ADDENDUM NO. 1

**RE: Item #7, November 6, 2024 Letting - PT 0908(105)349, PCN 07W6, Hanson, McCook County
- Spot Grading, PCC Surfacing, Crossover, Structures (8x8 CIP or Precast RCBC, 2-9x4
Precast RCBC, 11x5 Precast RCBC)**

PLANS: Please destroy sheets A2, B5, F2, F3, F4, F6, F26, F27, S2, and S5 and replace with the enclosed sheets, dated 10/28/24 and 10/29/24.

STANDARD CRC PLACEMENT DETAIL

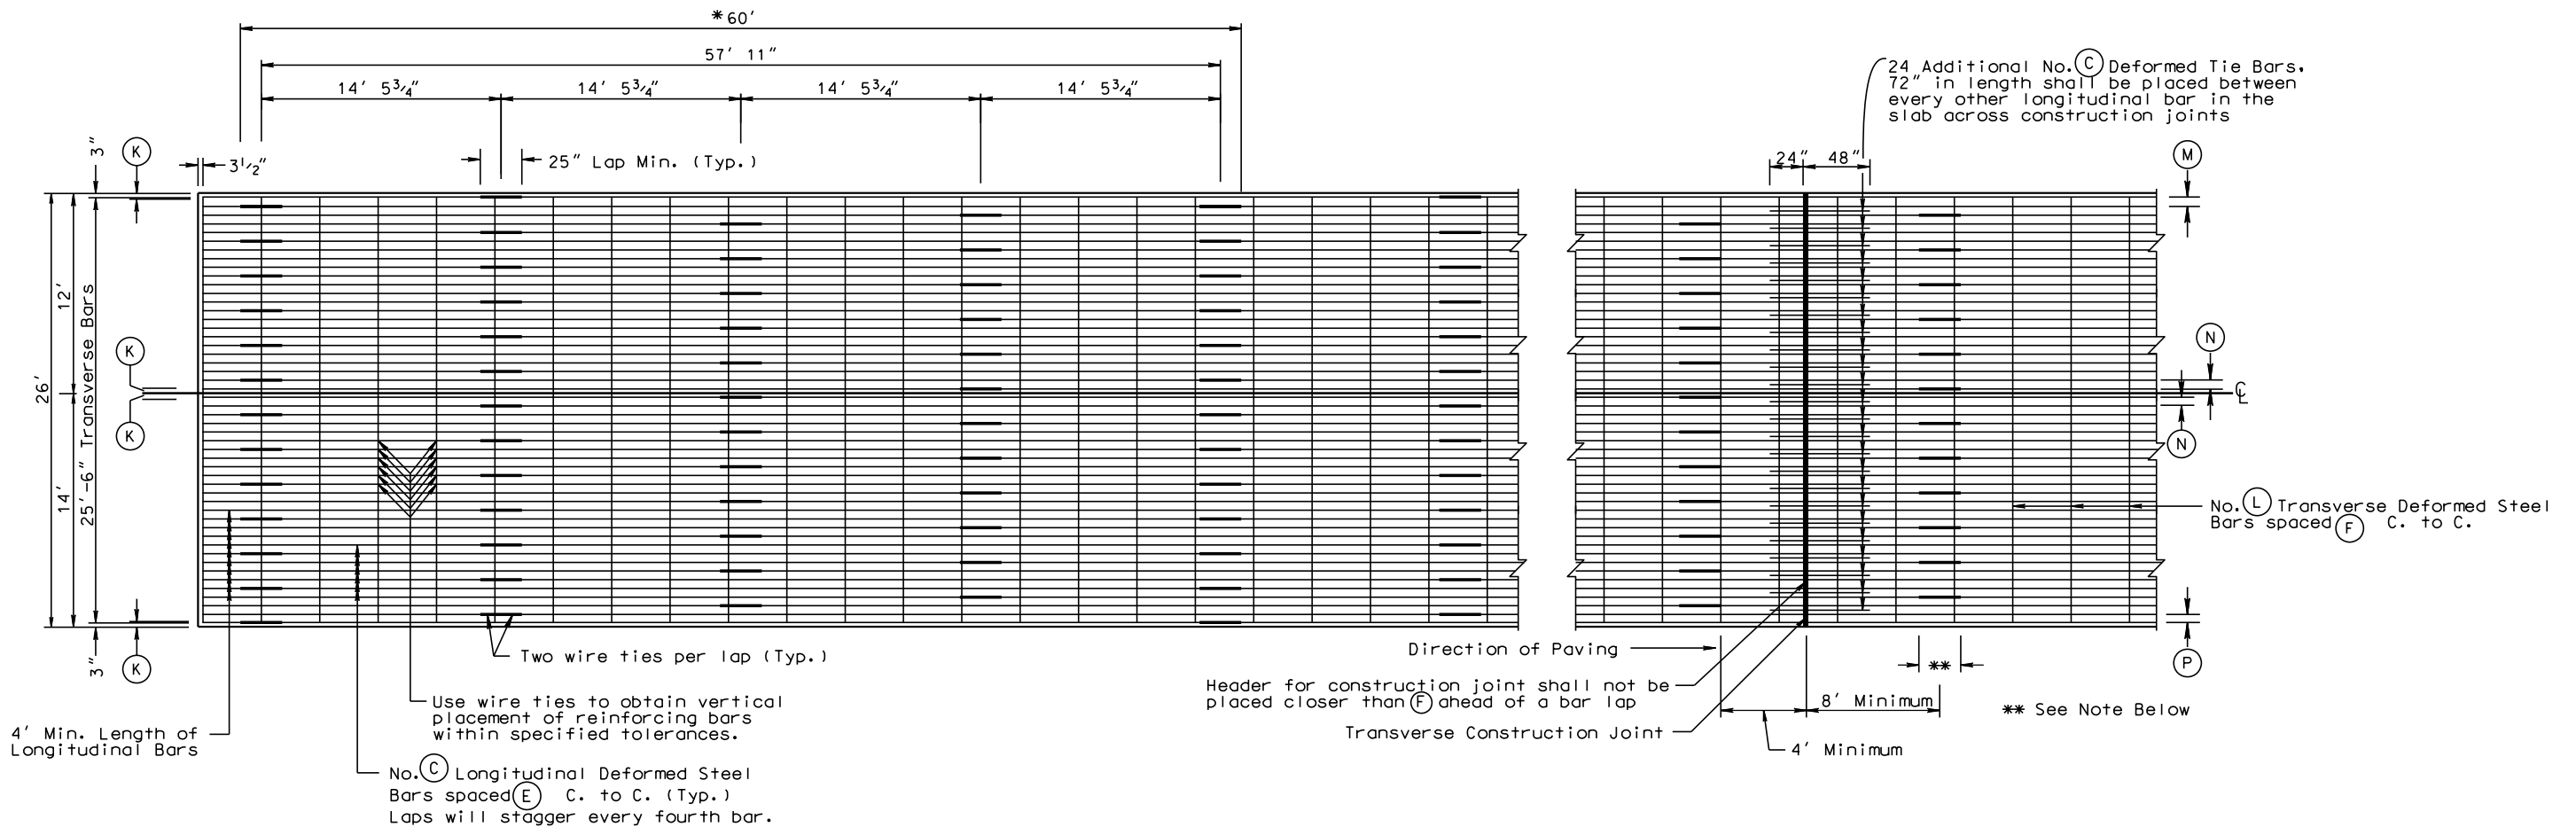
Sheet F26: STANDARD CRC PLACEMENT DETAIL tables were revised.

CRC Depth	CRC Width	Longitudinal Steel		Transverse Steel		Perimeter Bar Spacing			
		Size	Spacing	Size	Spacing	(K)	(M)	(N)	(P)
T	W	(C)	(E)	(L)	(F)	(K)	(M)	(N)	(P)
10.5"	26'	6	6 1/2"	4	42"	3 3/4"	6 1/2"	6 1/2"	4 1/2"

CRC Depth	CRC Width	Longitudinal Steel		Transverse Steel		Perimeter Bar Spacing			
		Size	Spacing	Size	Spacing	(K)	(M)	(N)	(P)
T	W	(C)	(E)	(L)	(F)	(K)	(M)	(N)	(P)
10.5"	26'	6	6 1/4"	4	42"	3"	6 3/4"	6 1/4"	5 1/4"

CRC PAVEMENT CHAIR DETAILS

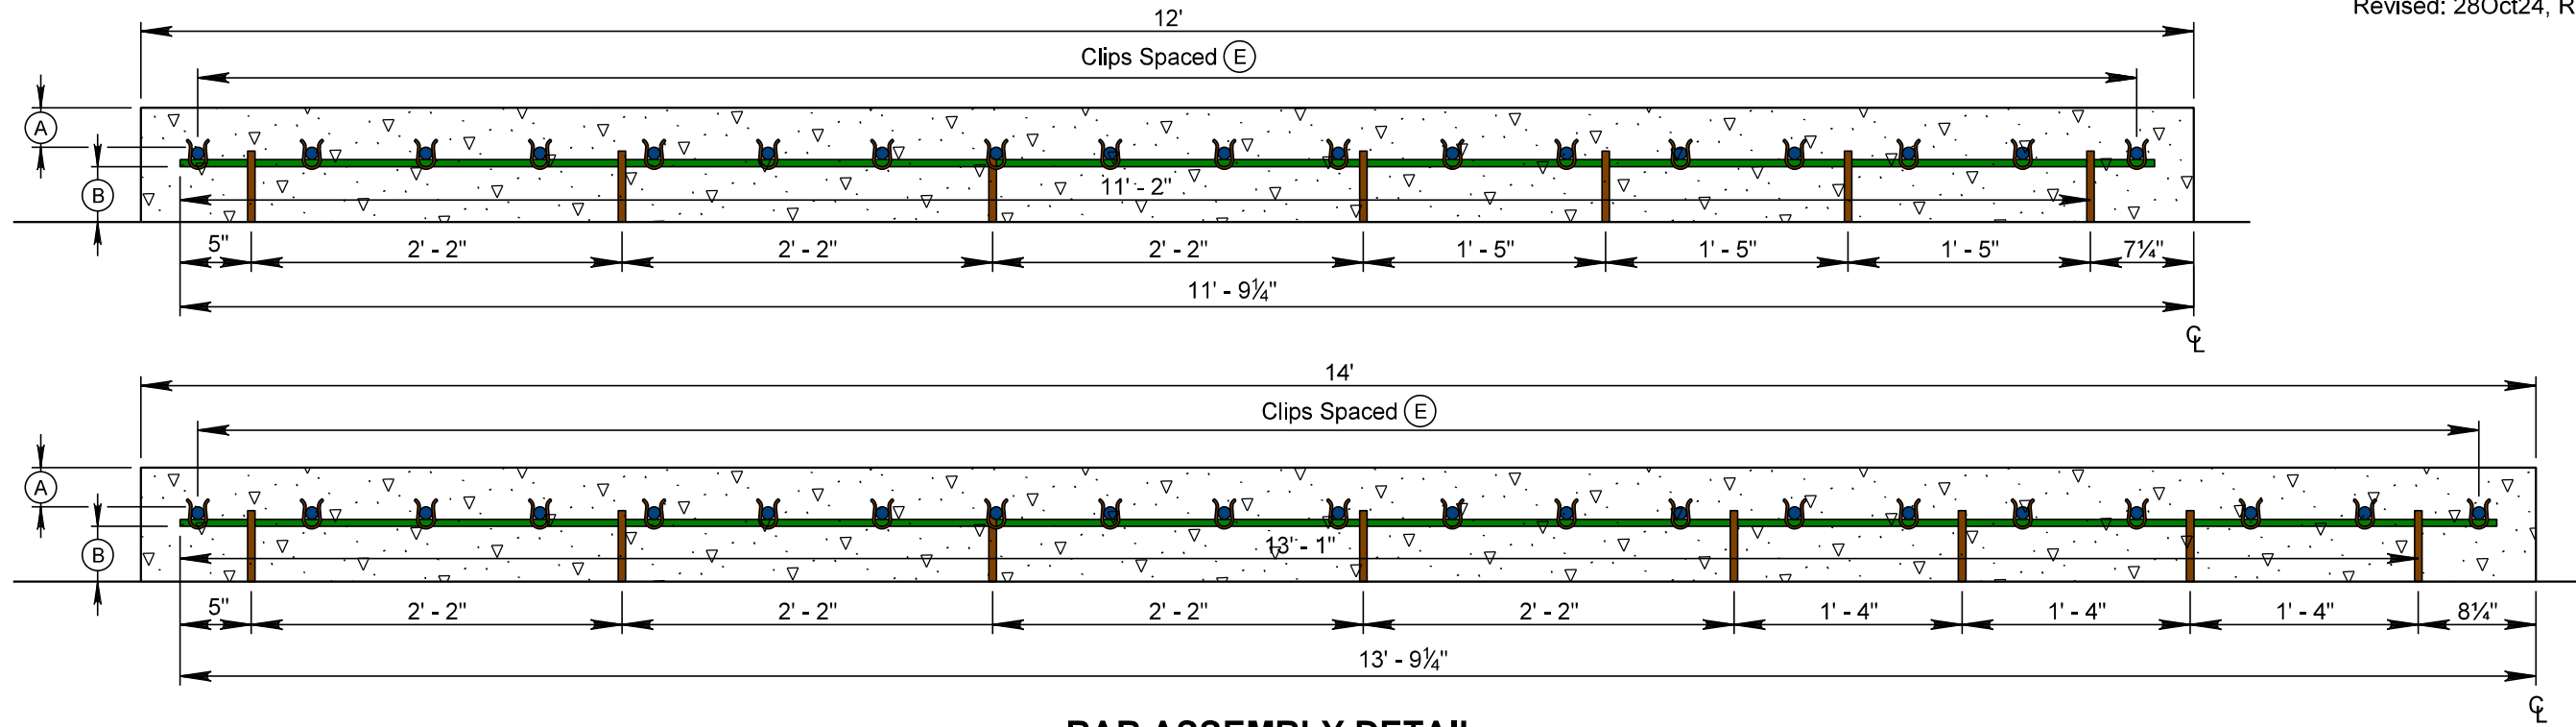
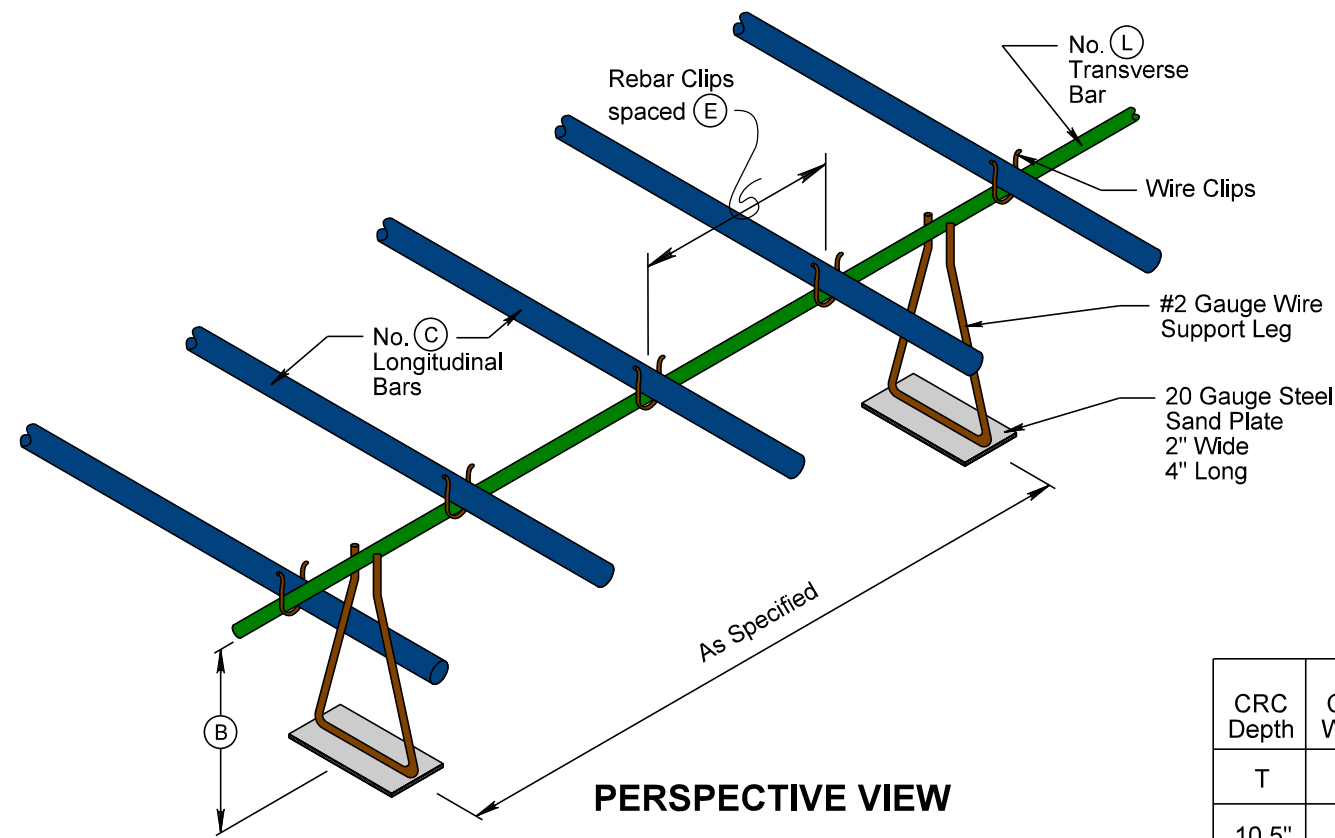
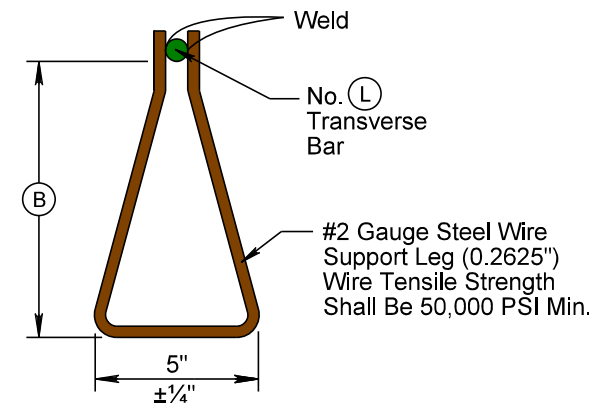
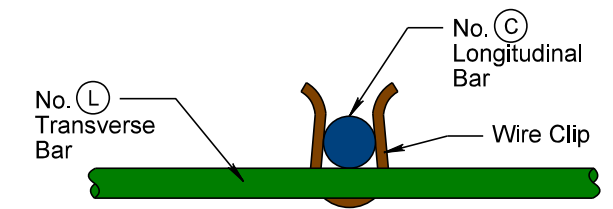
Sheet F27: CRC PAVEMENT CHAIR DETAIL tables were revised.

CRC Depth	CRC Width	Longitudinal Steel		Transverse Steel		Clearance	
		Size	Spacing	Size	Spacing	Top	Bottom
T	W	(C)	(E)	(L)	(F)	(A)	(B)
10.5"	26'	6	6 1/2"	4	42"	3 3/4"	5 1/2"
